**Economic and Social Council**Distr.: General  
10 February 2016

**Economic Commission for Europe****Inland Transport Committee****World Forum for Harmonization of Vehicle Regulations****Working Party on General Safety Provisions****110<sup>th</sup> session**

**Regulation No. 110 (CNG and LNG vehicles)****Proposal for amendments to Regulation No. 110  
(CNG and LNG vehicles)****Submitted by the expert from the International Organization for  
Standardization\***

Figure H.1

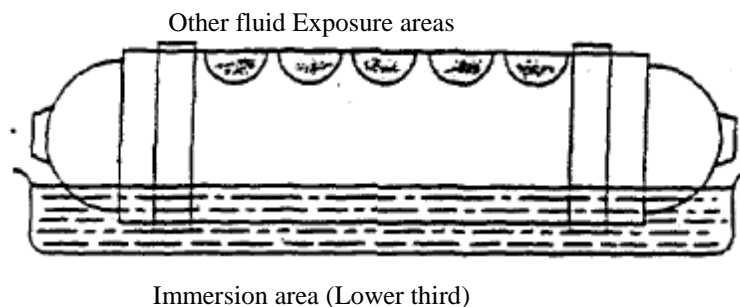
~~Cylinders will be tested horizontally and nominally divided along their horizontal centreline into "upper" and "lower" sections. The lower section of the cylinder will be alternatively immersed in road salt/acid rain environment and in heated or cooled air.~~

The upper section will be divided into 5 distinct areas and marked for preconditioning and fluid exposure. The areas will be nominally 100 mm in diameter. The areas shall not overlap on the cylinder surface. While convenient for testing, the areas need not be oriented along a single line, but shall not overlap the immersed section of the cylinder.

Although preconditioning and fluid exposure is performed on the cylindrical section of the cylinder, all of the cylinder, including the domed sections, should be as resistant to the exposure environments as are the exposed areas.

Figure H.2  
Gravel impact test

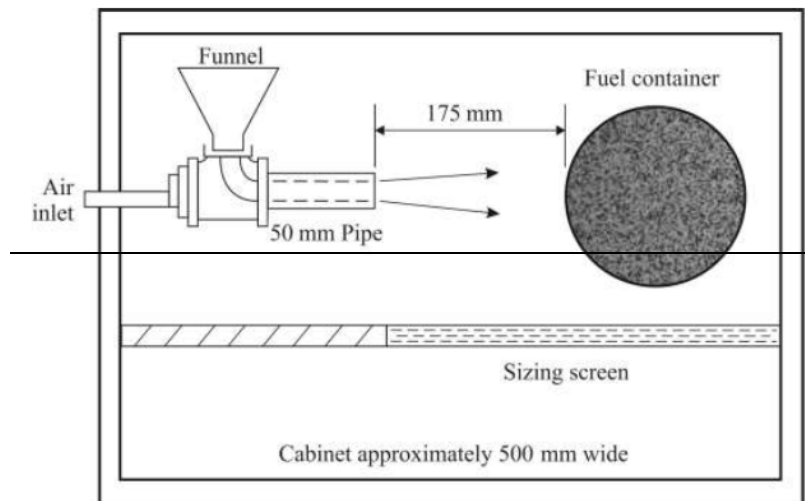
(b) — Gravel impact

~~Machine constructed according to the design specifications shown in Figure H.2. This procedure for operation of the equipment shall follow that described in ASTM D3170, Standard Test Method for Chip Resistance of Coatings with the exception that the cylinder may be at ambient temperature during gravel impact;~~

(c) — Gravel

~~Alluvial road gravel passing through a 16 mm space screen but retained on a 9.5 mm space screen. Each application is to consist of 550 ml of graded gravel (approximately 250 to 300 stones).~~
